Babylon Casualwear Ltd

Plot-23,24, Tetulzhora, Hemayetpur, Savar, Dhaka
(23.792784N, 90.254587E)
29 March 2014

Observations

Typical Column Layout

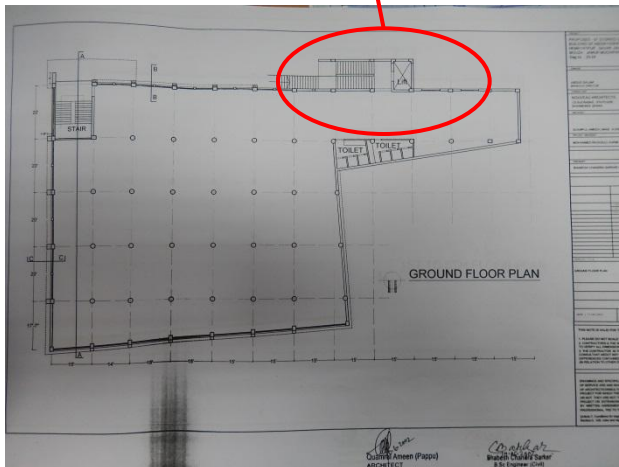
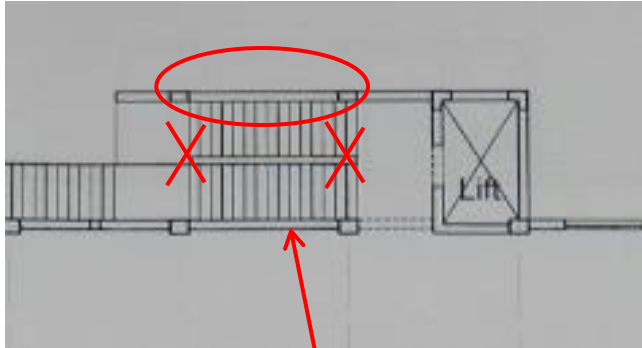
Drawings below indicate column at external wall of stairs.
X indicate external column location

Cursory review of the stairwell column layout has changed to a cantilever carrying 7 storey loads

Building Engineer to check that columns have been designed to accommodate applied loads.

Roof & Level 1 (Unit 1) slab & columns

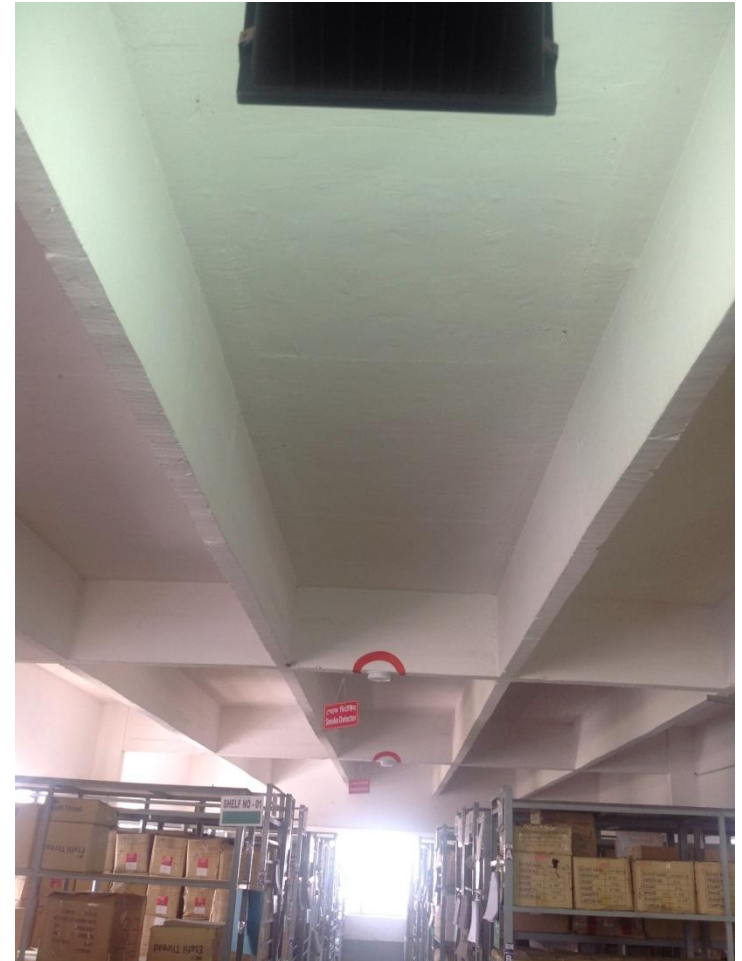
Roof level of 7 storey building has utilised pan slab & T columns in lieu of 2 way slab and circular columns. Particular focus on the transition (bottom left photo).

Level 1 slab of 7storey building has utilised a one-way slab in lieu of two-way slab in one section. Drawings do not indicate a one-way slab

Item No.	Observation	Recommended Action Plan	Recommended Timeline
13	Different design to the Unit 1 roof slab	Column and slab capacity to be assessed for existing loadings as part of Detail Engineering Assessment (see Item 1).	6-weeks
14	Different design to the Unit 1 roof slab	Provide accurate as-built documentation as part of Detail Engineering Assessment	6-months
15	Crack in beam adjacent to water tank location – Unit 2	Building Engineer to assess whether the building structure can carry the additional point load and submit relevant design document	6-weeks
16	Crack in beam adjacent to water tank location – Unit 2	Building engineer to assess the crack in the beam.	6-months
17	Crack in beam adjacent to water tank location – Unit 2	Carry out remedial work if required.	6-months
18	Lateral stability of single storey industrial buildings, and 2-storey steel frame building (Shed 1)	Building Engineer to assess whether building has an appropriate lateral stability system and submit relevant design document	6-weeks

Cracking in beam adjacent to water tank – Unit 2

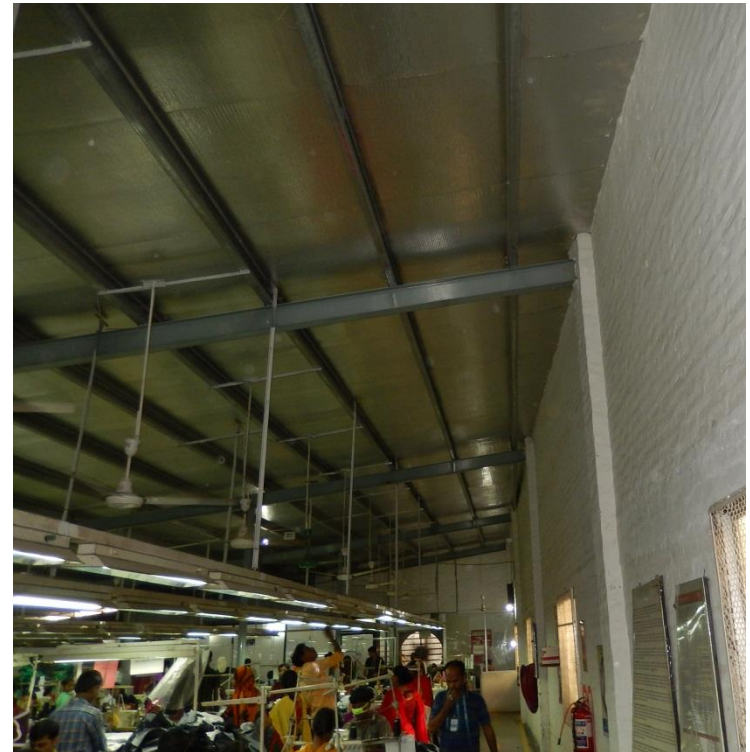
Vertical crack in column in proximity of water tank in Unit 2. Note tank sitting on slab without plinth.
